Product / Process Change Notification (PCN)

PCN Number: PCN_ConMJ_20241112 Affected Series: WR-MJ Affected Order Codes: 634108150321 PCN Date: 2024-08-12 (YYYY-MM-DD) Effective Date: 2024-11-12 (YYYY-MM-DD)	Change Category: <input type="checkbox"/> Equipment/Location <input checked="" type="checkbox"/> General Data <input type="checkbox"/> Material <input type="checkbox"/> Process <input type="checkbox"/> Product Design <input type="checkbox"/> Shipping/Packaging <input type="checkbox"/> Supplier <input type="checkbox"/> Software
Contact: Product Management Phone: +49 (0) 7942 - 945 5001 Fax: +49 (0) 7942 - 945 5179 E-Mail: pcn.eican@we-online.com	Datasheet Change: <input checked="" type="checkbox"/> Yes <input type="checkbox"/> No Attachment: <input type="checkbox"/> Yes <input checked="" type="checkbox"/> No

Before Change	After Change

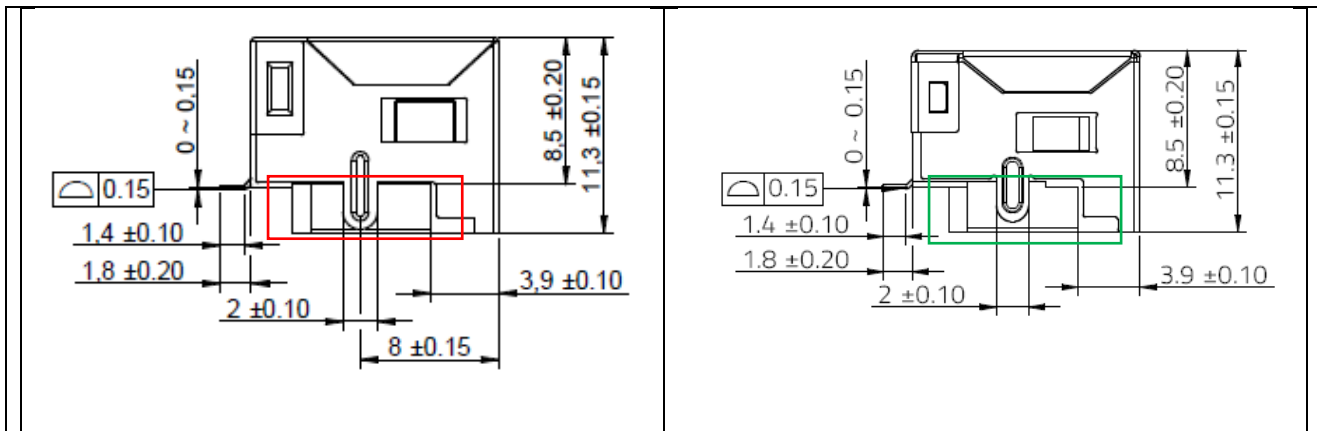
As a datasheet information amendment, Würth Elektronik eiSos is adding additional detail on the product drawing. This is a datasheet correction only. There will be no change in form, fit, function, quality or reliability of the product.
